# LACHLAN'S LINE LOT 110

## RESIDENTIAL APARTMENT BUILDING DEVELOPMENT APPLICATION - ALTERATIONS & ADDITIONS

5 HALIFAX STREET,  
MACQUARIE PARK

1 LEVEL 8 (LEVEL 11, 14 SIMILAR)  
1:200

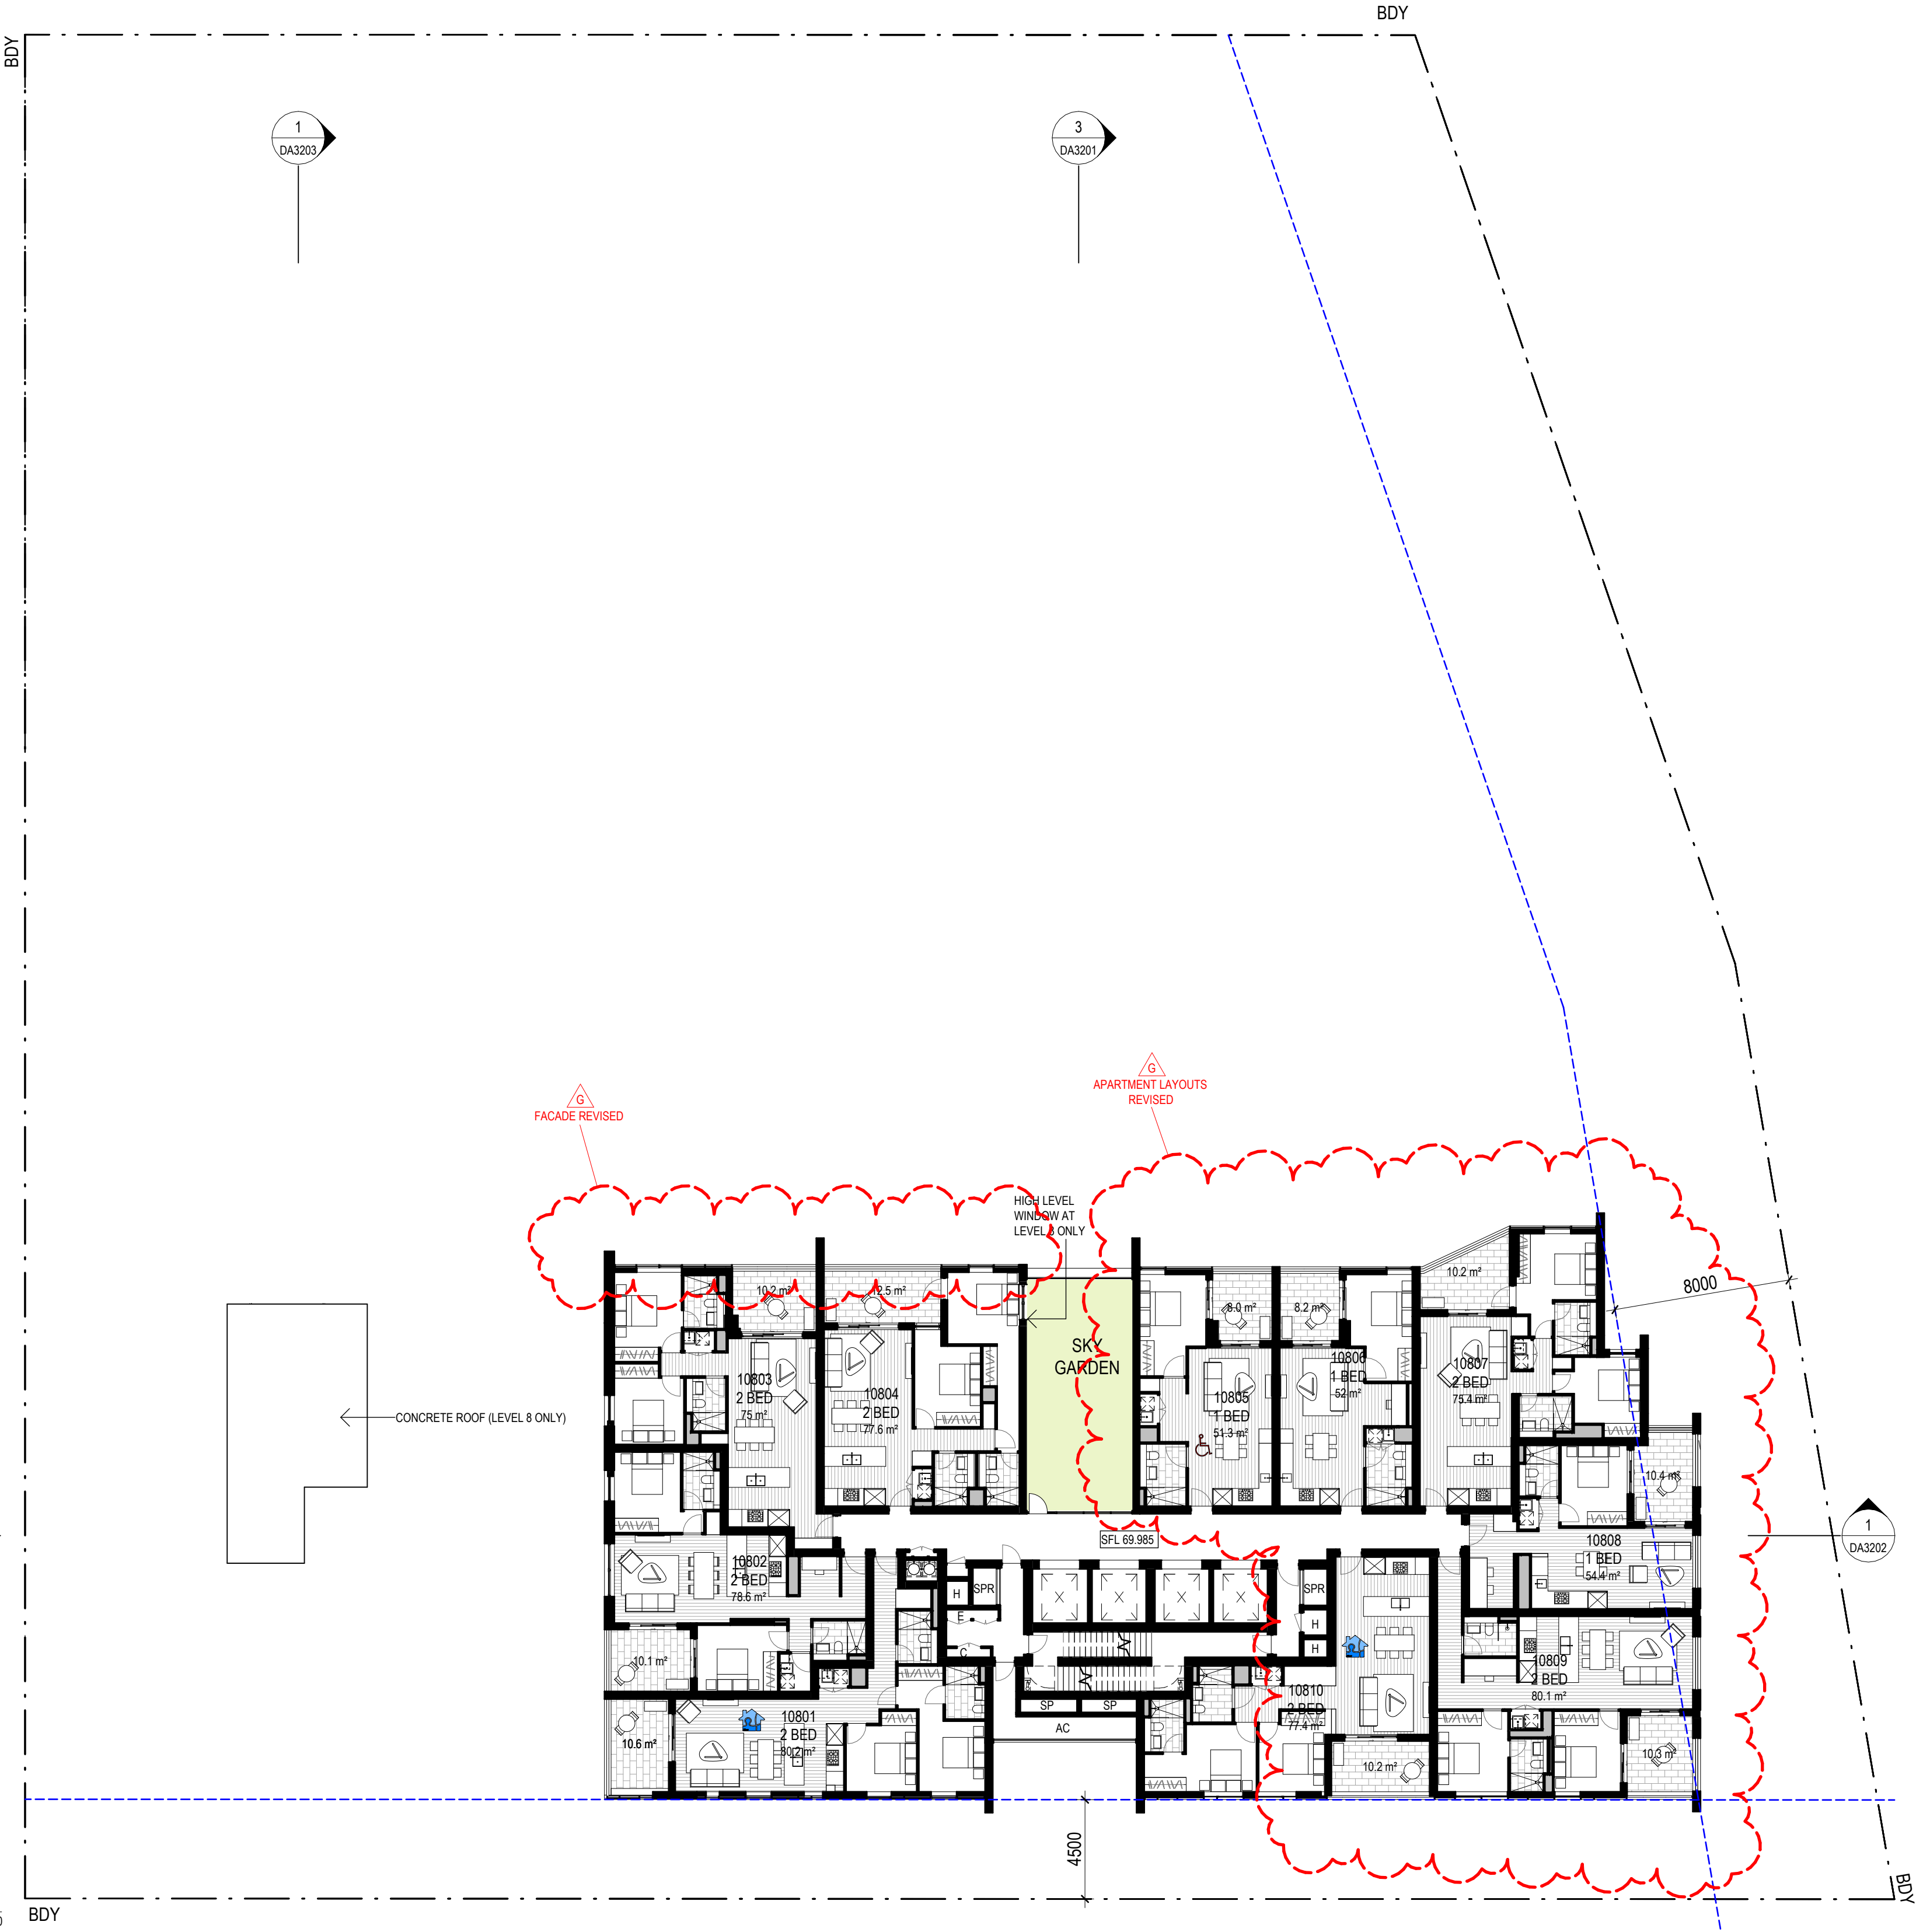
FACADE REVISED

APARTMENT LAYOUTS  
REVISED

HIGH LEVEL  
WINDOW AT  
LEVEL 8 ONLY

CONCRETE ROOF (LEVEL 8 ONLY)

APARTMENT RISERS,  
COLUMNS, A/C  
CONDENSERS REVISED

1 LEVEL 9 (LEVEL 12, 15 SIMILAR) 1:200

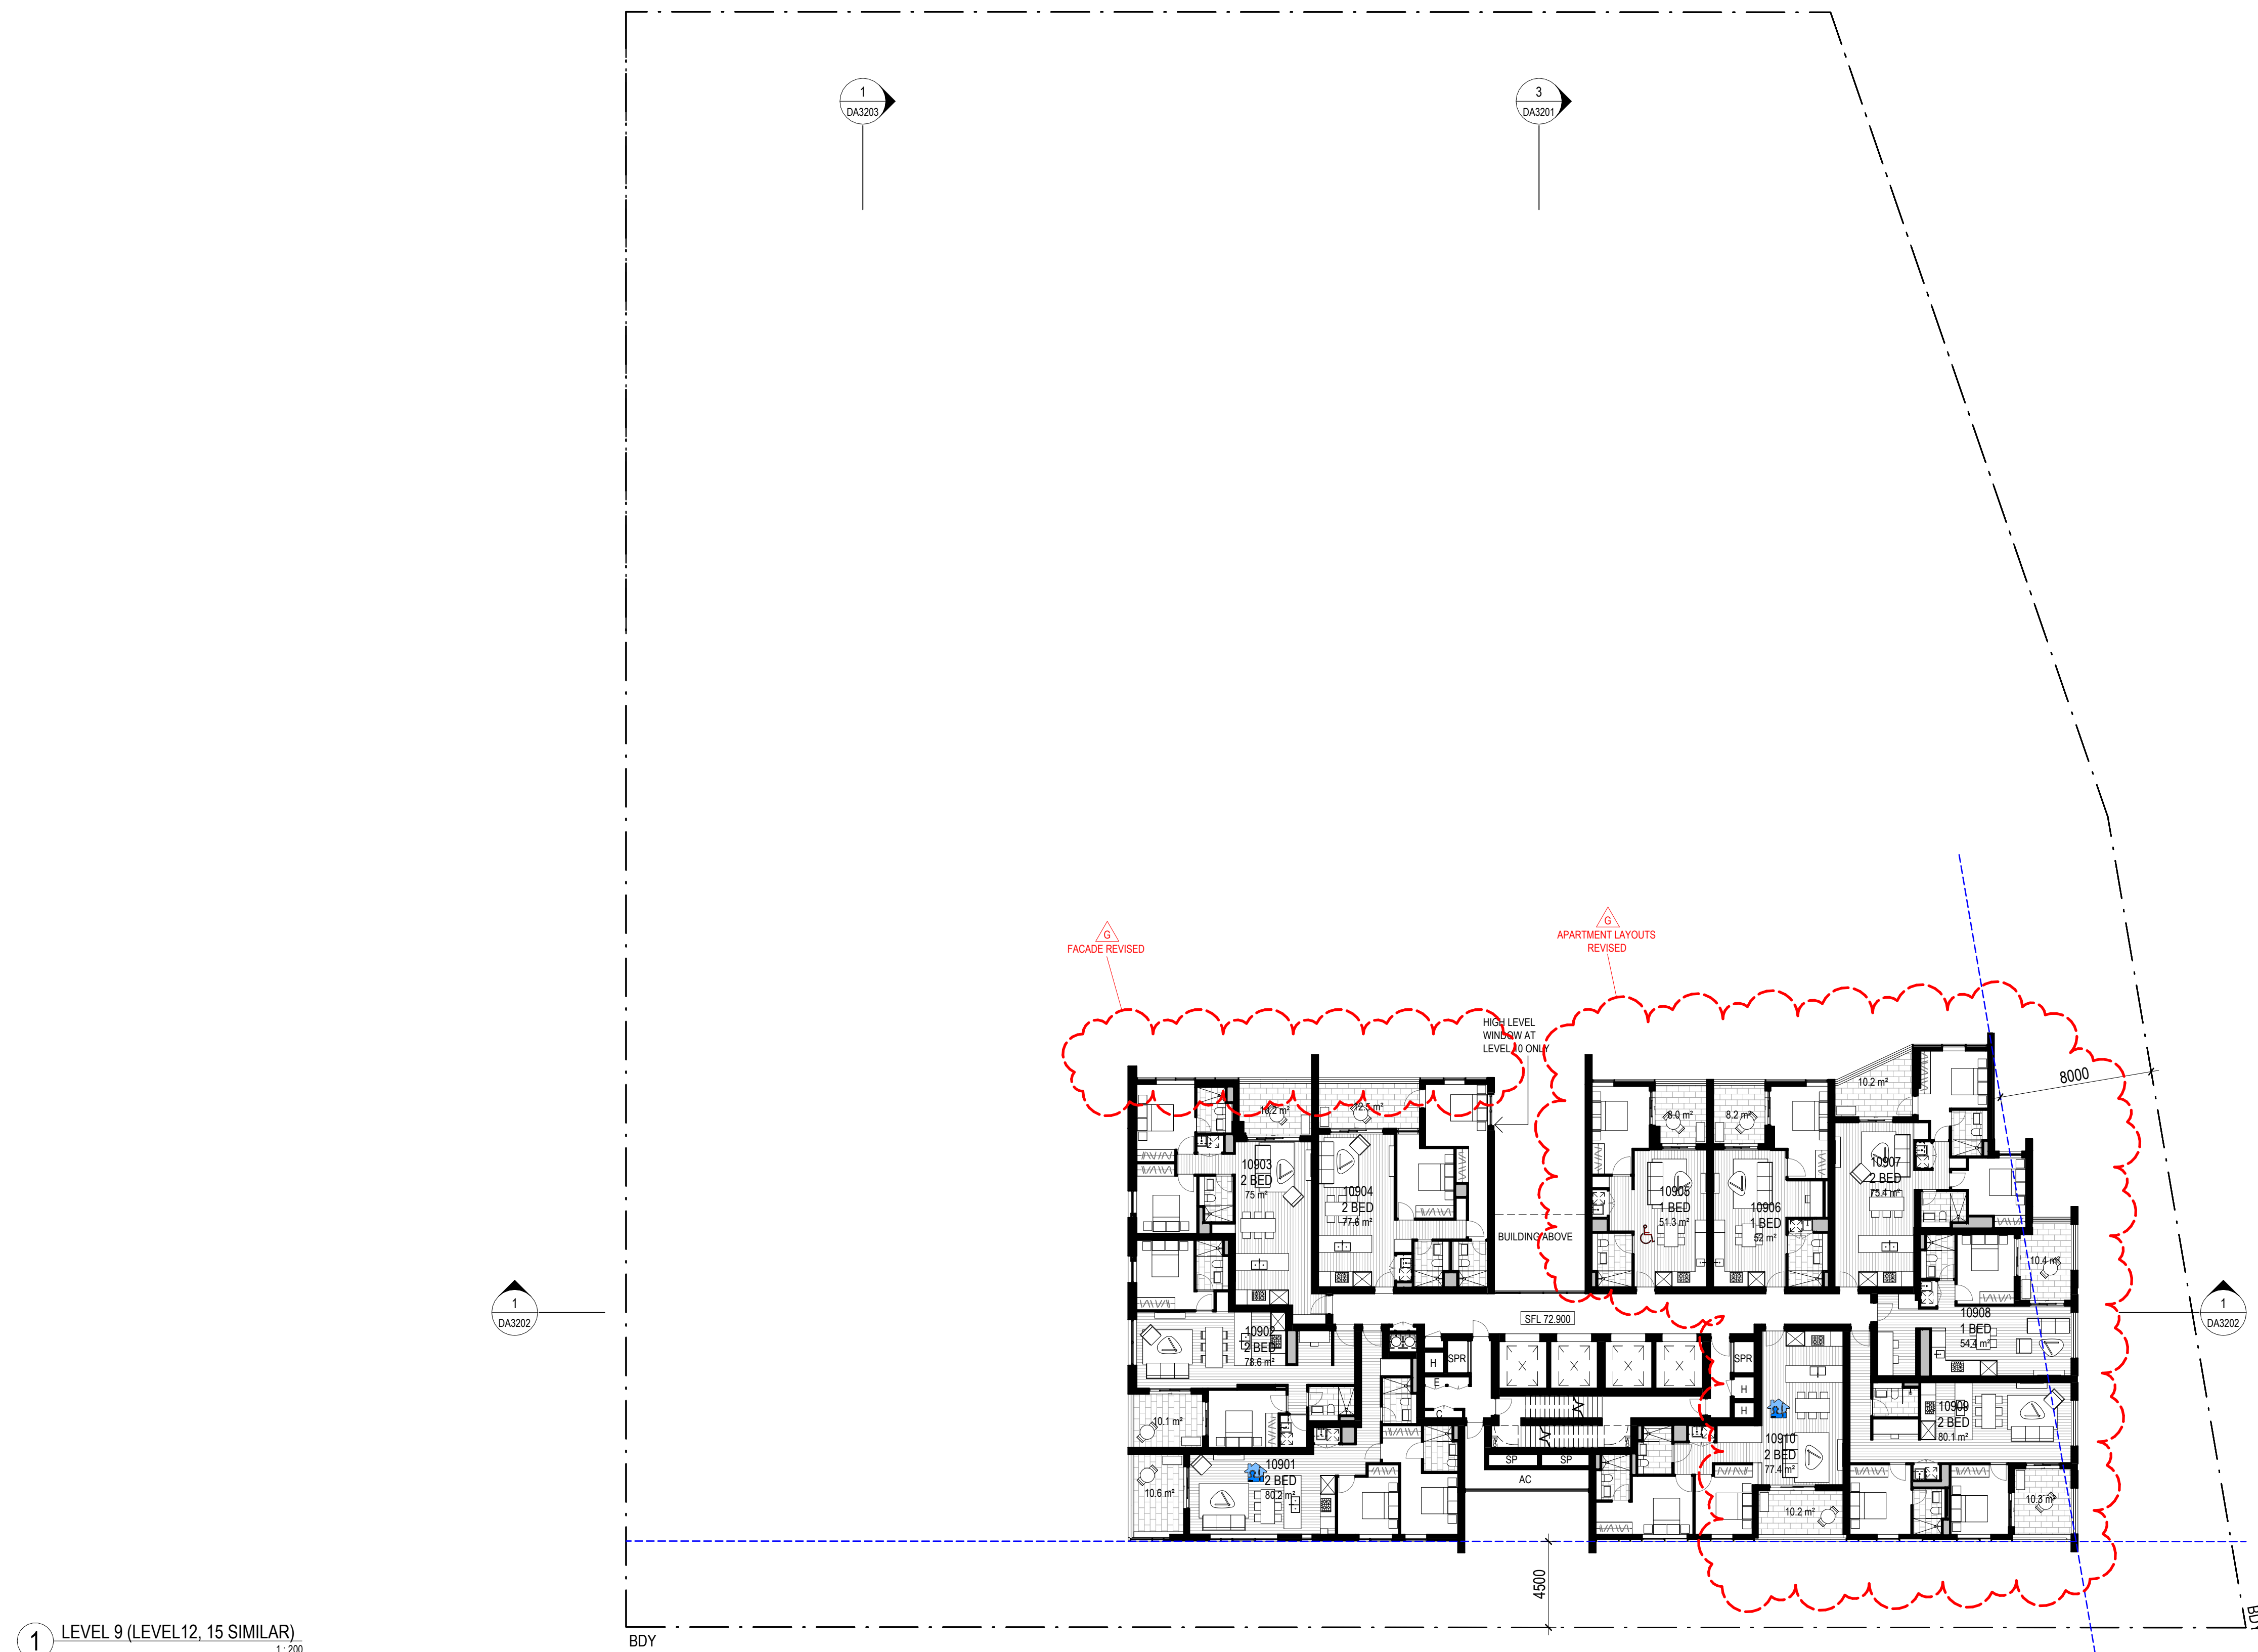
APARTMENT RISERS,  
COLUMNS, A/C  
CONDENSERS REVISED

2 FLOOR PLAN - LEVEL 25, (LEVEL 26-30 SIMILAR)  
1:200

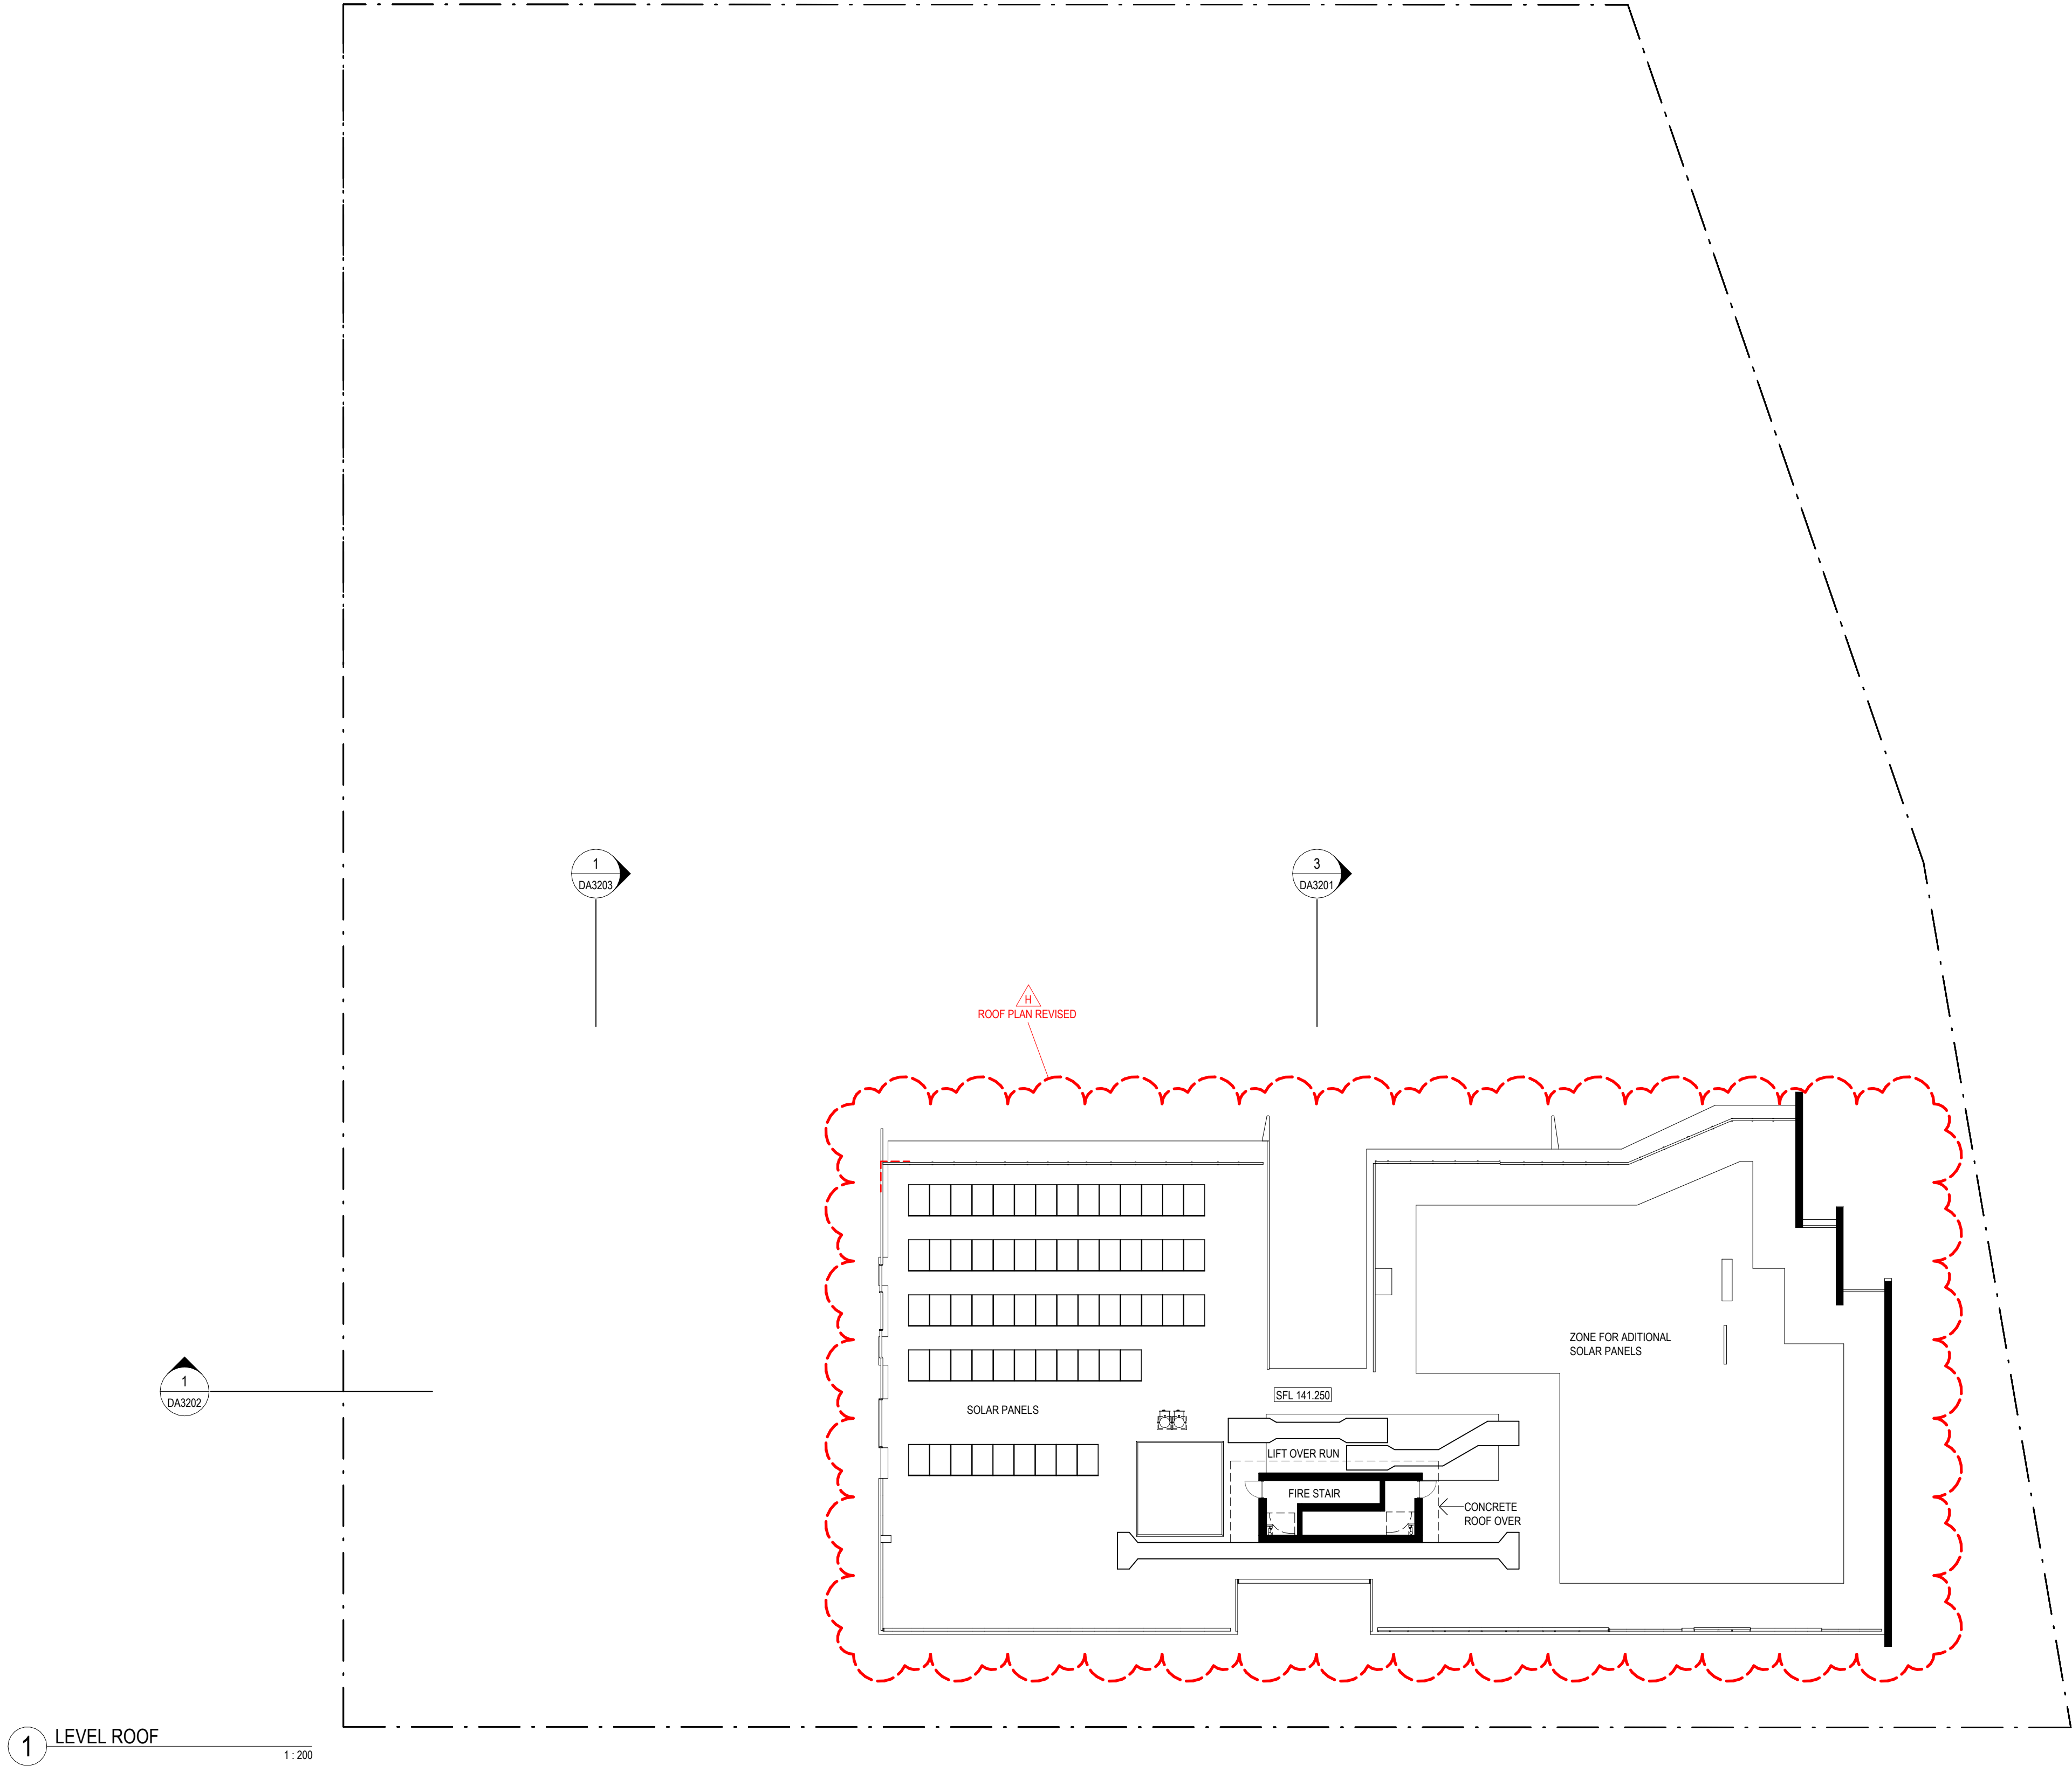
FACADE REVISED

APARTMENT LAYOUTS  
REVISED

APARTMENT RISERS,  
COLUMNS, A/C  
CONDENSERS REVISED
